BULLETIN No BE 105/93 SWIFT

Strengthening of the structure of the pedal arms in the rudder control system

Indicatory sketch:

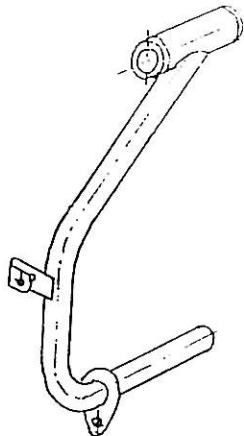
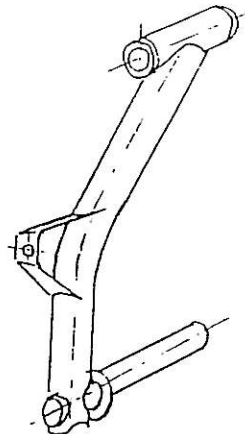
The pedal arm (drawing A/2-1.05.100) has been strengthened by means of enlarging the diameter of tubular element, and also the type of steel has been changed to obtain greater stiffness, strength and material plasticity.
